Dennistoun Community Council response to Glasgow City Council reply dated 5th October 2021 regarding queries submitted to the Dennistoun Area Partnership.

Tuesday 2nd November 2021

DENNISTOUN COMMUNITY COUNCIL
Observations along Hillfoot Street/Roslea Drive One-way section
+ additional references to other locations requiring maintenance

1) Hillfoot Street

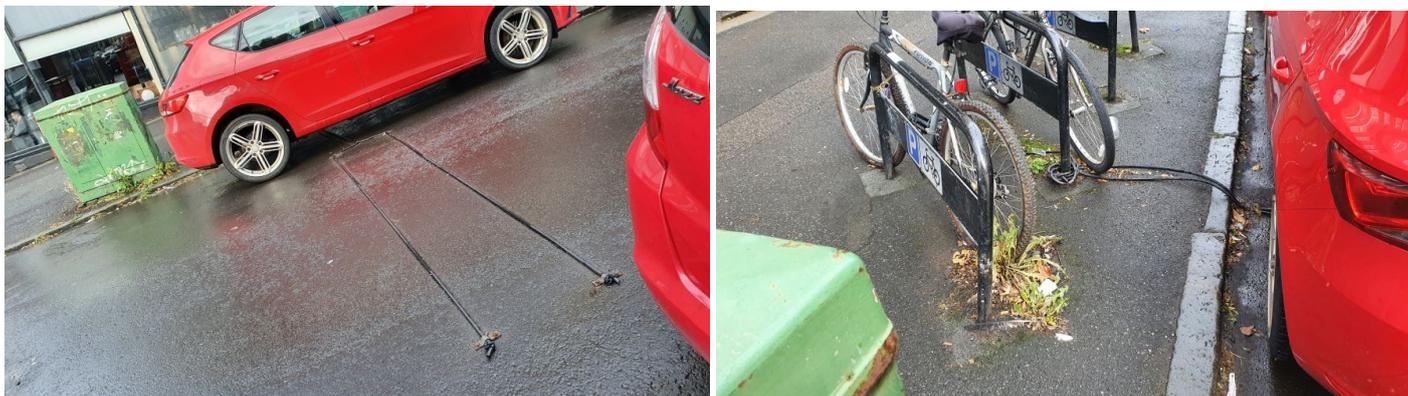
- a) Apparent inconsistencies and/or contradictions (with StreetView image included for comparison):
 - i. Double yellows now terminate asymmetrically at gullies on each side, rather than what was apparently a measured and equal length previously;

- ii. No single yellow lining present now, compared to previously;
 - iii. No kerb markings present now, compared to previously;
 - iv. Signs for time-restricted parking and loading are still in place, as previously.

- b) Parking plate on bent pole.
- c) Parking information signs having to fight for attention with GCC 'Monitored site' dumping sign, GCC dog fouling sticker, remnants of an old GCC notification left behind after roadworks, minicab taxi sticker, estate agent sign, and multiple zip ties, all on the same rusting lighting column.

- d) Sign pole located absolutely central to desire line of pedestrian travel.
- e) Abandoned cones (three within view in these images, multiple others in very near vicinity).
